SUBMISSION:
PARRAMATTA LIGHT RAIL
IN REFERENCE TO 32 TRAMWAY AVENUE, PARRAMATTA

INTRODUCTION

Figure 5.30 James Ruse Drive Bridge cross-section (Indicative)

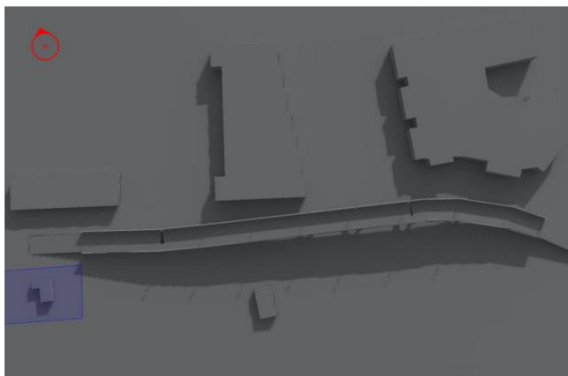
As shown in the figures below from the EIS, it is anticipated that there will be some overshadowing impacts on the property due to the grade separation bridge on James Ruse Drive. This will create a significant amenity issue with the lower levels of the proposed development facing the bridge, however additional detail on the separation and design of the bridge is required.

The proposed development will be impacted by the large bridge structure to its north, which may present ADG compliance issues (further design documents required). While it is not up to the PLR to implement planning regulations, an appropriate solution to the visual and acoustic impacts created by the proposal is to facilitate the increased density of properties along the PLR.
